Office Action Summary

10/780,966

KIM ET AL.

Claim Rejections - 35 USC § 102

FIG. 5

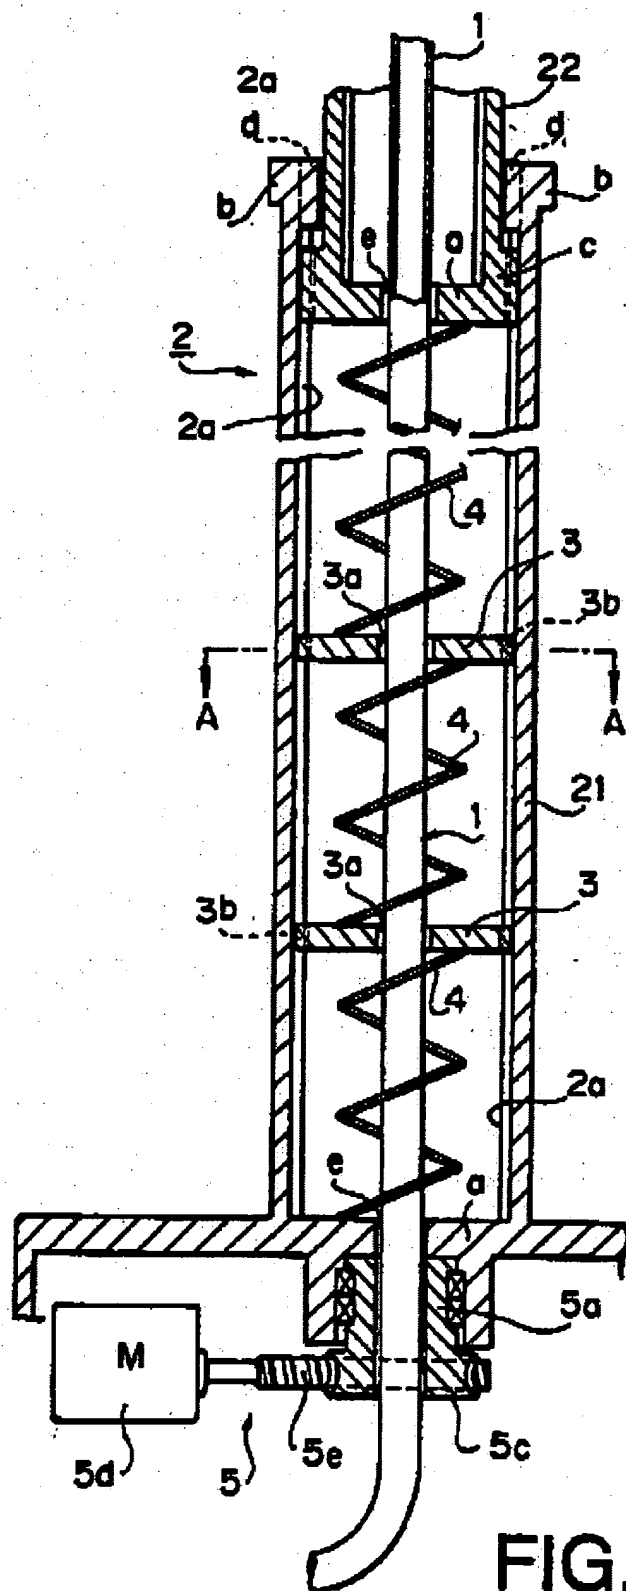
Claims 1 are rejected under 35 U.S.C. 102(b) as being anticipated by Atsukawa(US005279084). Atsukawa teaches a movement mechanism for a telescoping column. In regards to claims 1, and referring to figure 5, the support mechanism comprises a housing (b) with a motor (M), a driving gear(5e) rotated by said motor with a driven gear (5a) in the form of a rotatable nut member(C3 L57-61), which has a spiral groove in the central portion of the nut with the gears being tooth engaged, a flexible screw member (1) which moves linearly up and down through the driven gear and further comprising a telescoping unit including a plurality of sliding members that cooperate with the screw member.

FIG. 2

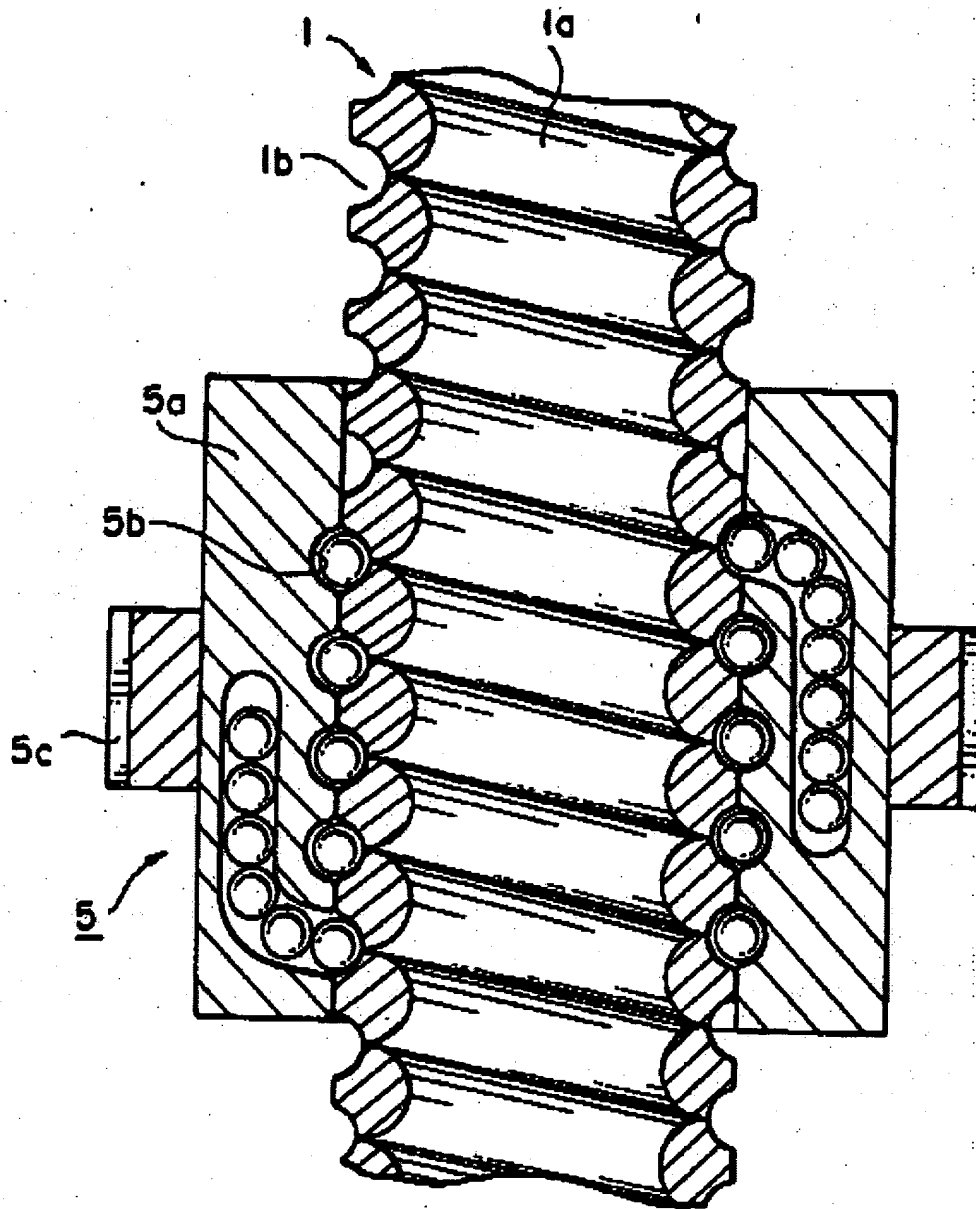
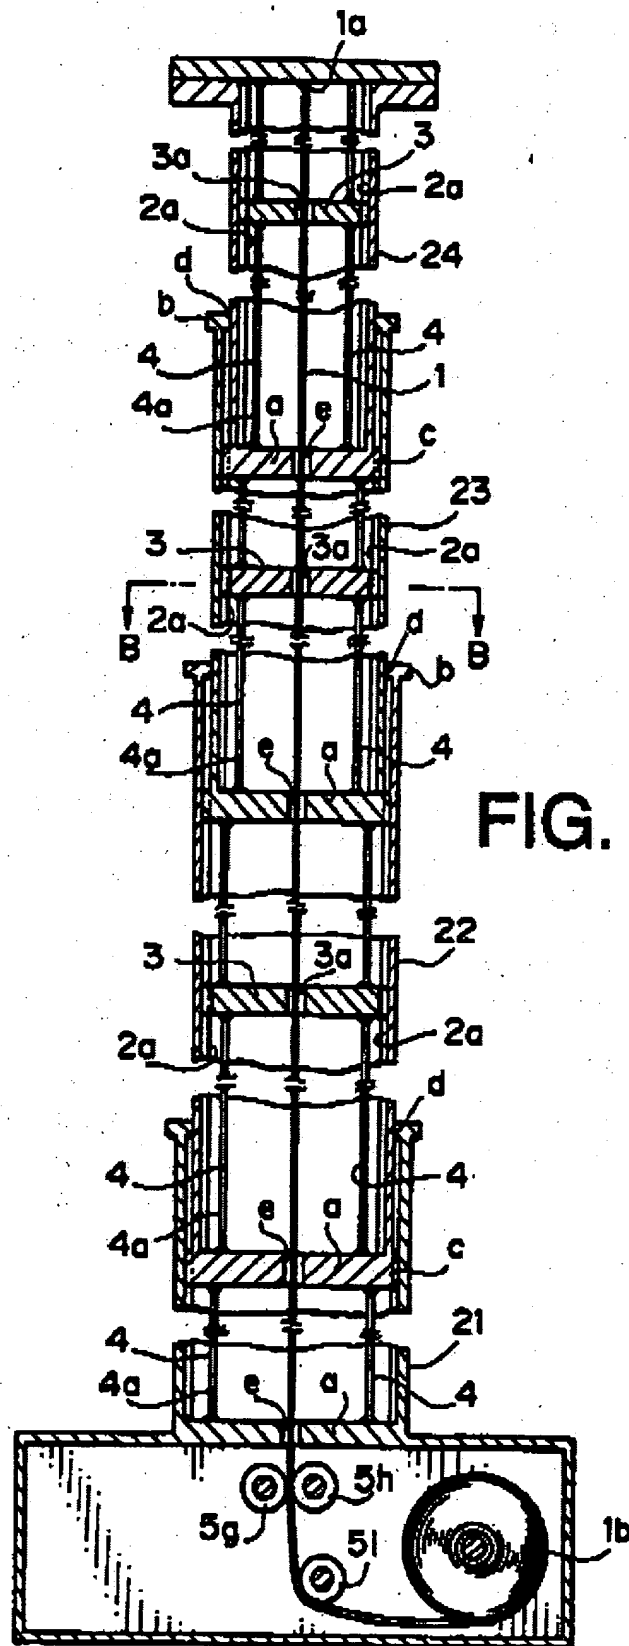
Claim 2 is rejected under 35 U.S.C. 103(a) as being unpatentable over Atsukawa. As can be seen in figure 2, one embodiment of the flexible screw member(1) is a coil spring, further it would have been obvious to one of ordinary skill in the art the replace the flexible screw member of figure 5 with the coil spring in figure 2 since Atsukawa states that this embodiment has substantially the same appearance as the usual rod member, as well as being flexible in the axial direction(C4 L30-35), which would be desired as the rod member is flexed axially after it is drawn out of the driven gears and telescoping tubes, as can be seen in figure 5.
